Agenda Item #1

Application 2026-47-CA

155 Houston Street

Replace thirteen existing wood windows with aluminum-clad wood windows

Assessment of Window Condition

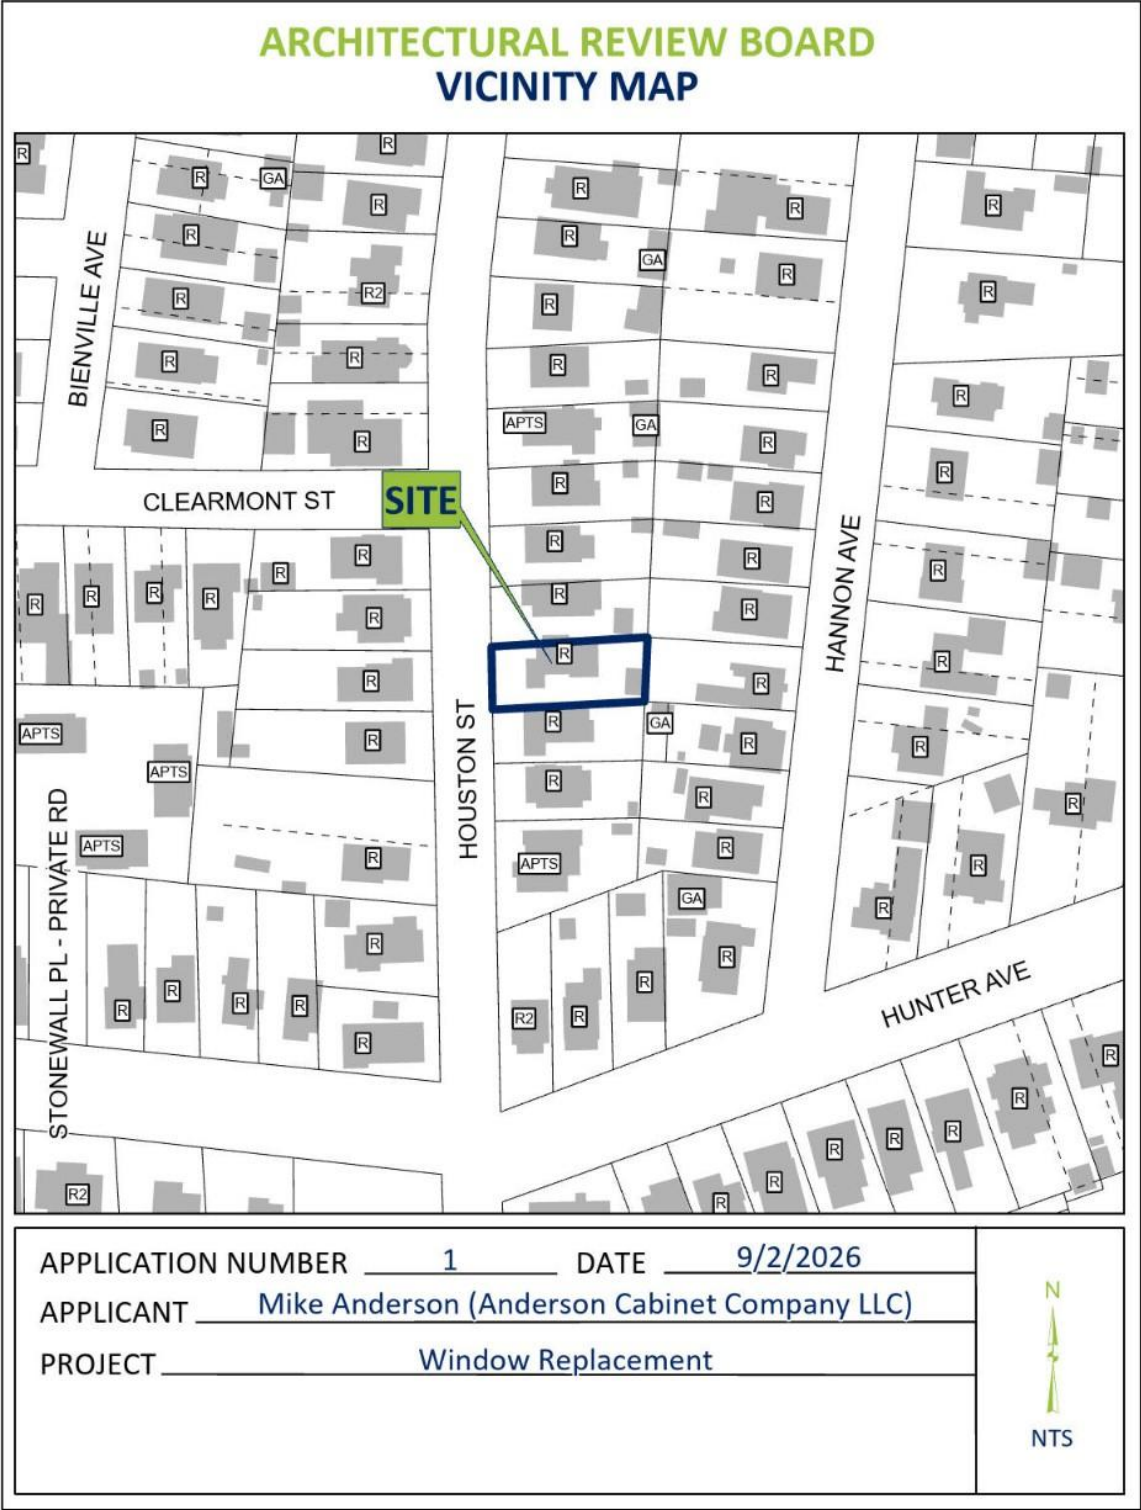
The *Guidelines* stipulate that historic wood windows should only be replaced if they have deteriorated beyond the point of repair. The window survey and photos submitted as part of the application indicate that the windows are

in repairable condition. Photographs do not depict any obvious signs of rot or termite damage to the wood sash and muntins. The glazing putty – which frequently is loose, cracked, or entirely missing on poorly maintained wood windows – is intact and well-adhered. This suggests that the windows have been reglazed fairly recently and otherwise well maintained. The glazing putty has blackened on nearly all windows. This commonly occurs if fresh window putty is painted over before it is allowed to dry fully. Excess moisture escapes from the putty as it cures, causing the paint surface to mildew. This can be removed with by washing the windows with a dilute dish soap solution. A small amount of bleach may be added to the water for stubborn staining. Once the mildew is removed, a fresh coat of paint treated with a mildewcide should prevent the blackening of the putty in future.
